NYN-95081

Subject: Relief Request From ASME Code Section XI Requirements

ENCLOSURE TO NYN-95081

SEABROOK STATION
FORM FOR RELIEF REQUEST FROM ASME SECTION XI REQUIREMENTS

ULTRASONIC THICKNESS EXAMINATION SKETCH

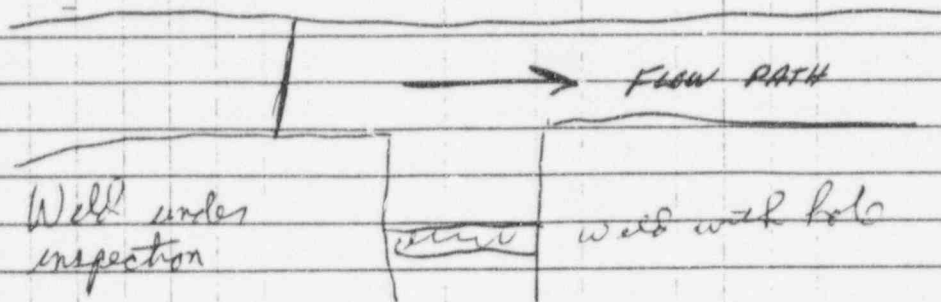
Scan show low point as .407 on pipe
and .548 on weld. Set is 7.600
No deterioration found

ULTRASONIC THICKNESS EXAMINATION SKETCH

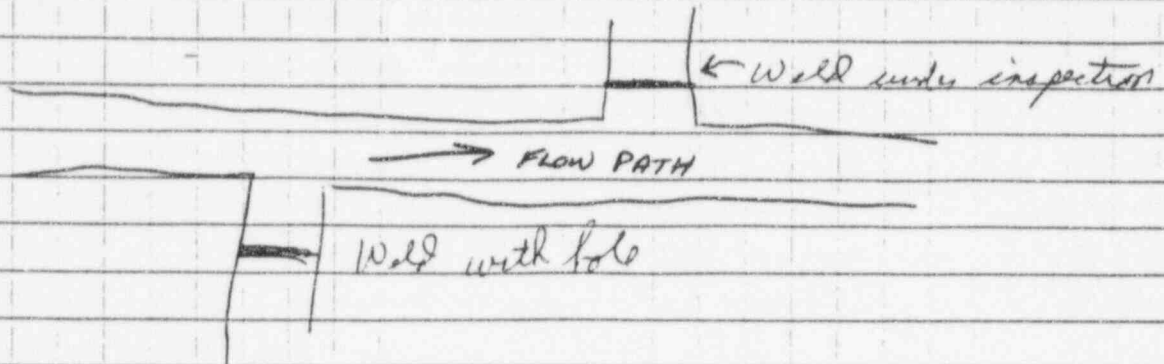
General area lowest points

Pipe .362

Weld .313

tee \approx .500

No deformation found

ULTRASONIC THICKNESS EXAMINATION SKETCH

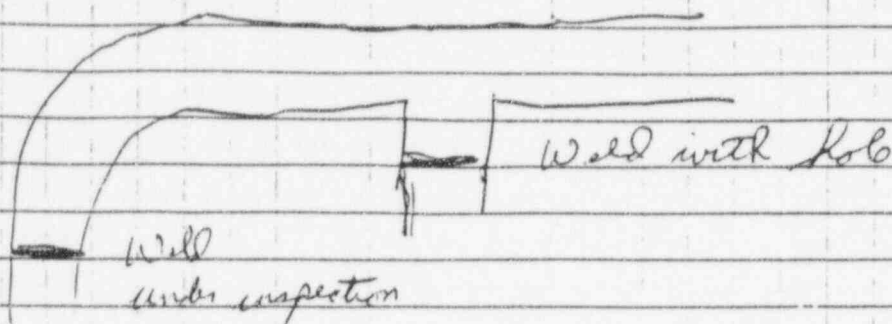
General area scan is
 elbows .330
 weld .290

No deformation noted

Subsurface indication interfering with UT
 yield found reading is .097.
 Indication most likely due to lack of
 fusion Area ~ 1 1/2" location is
 on upper elbow lower joint outside
 radius
